## Alpi Pioneer Aircraft (All Types) Inspection of Control Surface Hinge Attachment Cap Bolts

LAA/AWA/20/16  
9th June 2020  
Superseding LAA/AWA/19/23

### Extension of Compliance Time Due to the Corona Virus Outbreak

Fig 1. (Top) This sketch shows the inspection points within the empennage of all Pioneer types.

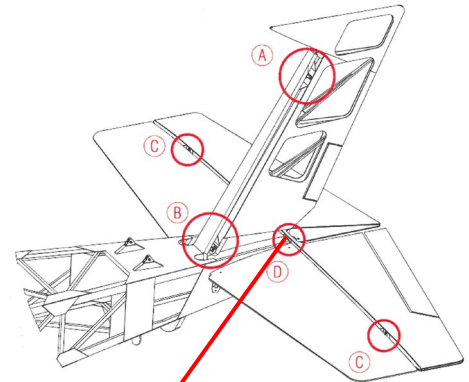
Because of this negative feedback, LAA Engineering issued an Airworthiness Information leaflet (AIL), for each Pioneer aircraft model. The AIL required the control surface attachment cap bolts to be removed, inspected and replaced with new cap bolts (if found corroded). When refitted, the cap bolt heads, secured into blind captive nuts, are required to be drilled to accept locking wire and, when refitted, wire-locked. Wire-locking these cap bolts removes the chance that a cap-bolt could become loose in service, wind itself out and, in doing so, potentially reduce control surface travel. We wrote about these events in the May 2019 edition of Safety Spot, a copy of which can be downloaded [HERE](#).

Fig 3 (Left) Shows severe corrosion in a cap-bolt as removed from a Pioneer aircraft operating in an overseas coastal environment.

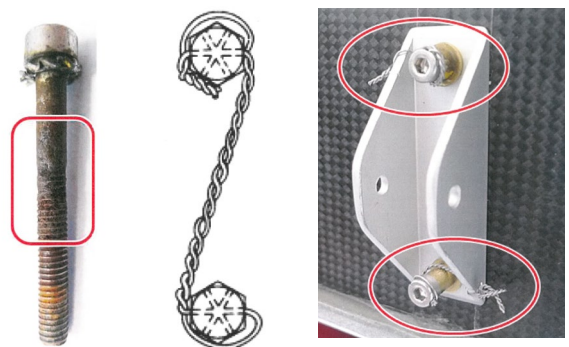
Fig 4. (Centre) Shows a conventional method of wire-locking pairs of bolts.

Fig 5. (Right) Shows a suitable alternative method of wire-locking a pair of bolts where the wire-locking may interfere with correct hinge operation.
